ROCKY FLATS SITE REGULATORY CONTACT RECORD

Purpose: Reportable Condition at the Original Landfill (OLF)

Contact Record Approval Date: October 21, 2013

To: Mr. Rick DiSalvo
Mr. Melvin Madril, PE
Mr. Stephen Pitton From: Thomas A. Chapel, CPG, PE
Company: S.M. Stoller Corporation Date: October 10, 2013
Rocky Flats OLF Berm 4 Grading
Re: and Drainage Project No.: 114-181750

Figure 1. General Location of Cracking Observed on OLF Cover

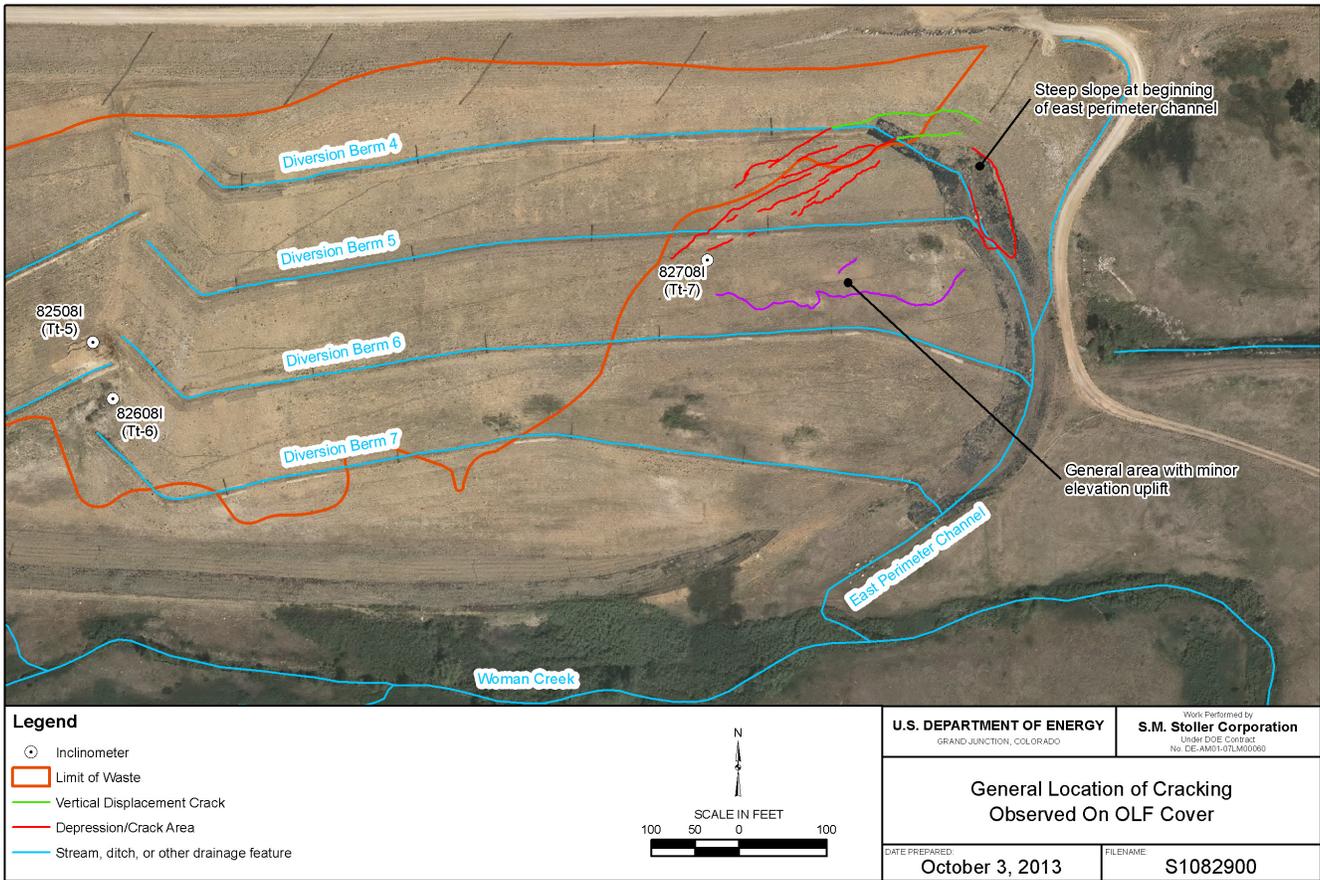
Cracks with vertical displacement of up to approximately 2 feet and cracks up to approximately 0.5 feet wide were observed during the inspection. The cracking and settling extended through portions of Diversion Berms 4 and 5, and a minor depression was formed in the Diversion Berm 4 channel between the cracks. Figure 1 shows the general location of the observed cracks based on handheld GPS measurements.

Figure 1. Slope Stability Model Results

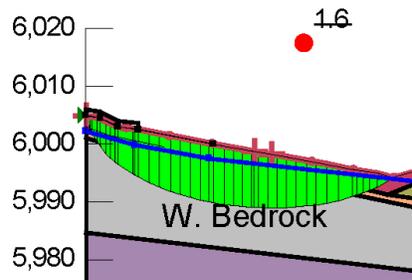
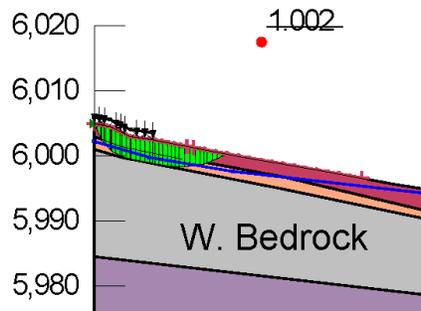
We have considered two alternative, short-term methods for reducing the occurrence of standing water in this area. Fill could be placed on the berm and in the channel invert to raise the lower portion so that positive drainage will occur across the zone. This alternative adds additional weight to the cracked area which tends to decrease the stability. Using previous slope stability models that we constructed as part of our geotechnical engineering evaluation, Tetra Tech simulated a wet condition and placement of additional fill by increasing the water level in the model and adding a surcharge to the ground surface at the failure plane. The surcharge applied approximates a two-foot layer of Rocky Flats Alluvium placed at the upper portion of the failure zone. Figure 1 (below) illustrates these conditions. Figure 1(a) shows the slope and localized failure with no surcharge, but with an elevated water level. The model calculated a minimum factor of safety (FoS) of 1.6, with failure occurring in the upper portion of the weathered claystone bedrock. Figure 1(b) shows the effect of adding a two-foot layer of fill as a surcharge. The calculated minimum FoS dropped

to 1.002 and the failure is predicted to occur in the organic layer at the surface of the weathered bedrock. These results indicate that the slope is marginally stable and on the verge of failure following the addition of two feet of fill. Because a localized, minor failure did actually occur when the water level increased, but without an additional surcharge, the model results may actually under-predict the potential risk of additional failures if surcharge is added.

Another alternative that would appear to have a lower risk for decreasing stability of the area is the construction of a temporary drain in the invert of Berm 4 to convey water from the low segment eastward to the outfall. This could be a trench and flexible drain pipe constructed such that the upper end of the drain is at the downstream end of the low segment and the drain outfall is at the eastern end of Berm 4 or in the EPC. This drain could be removed when longer term remedies have been designed and constructed (see below).
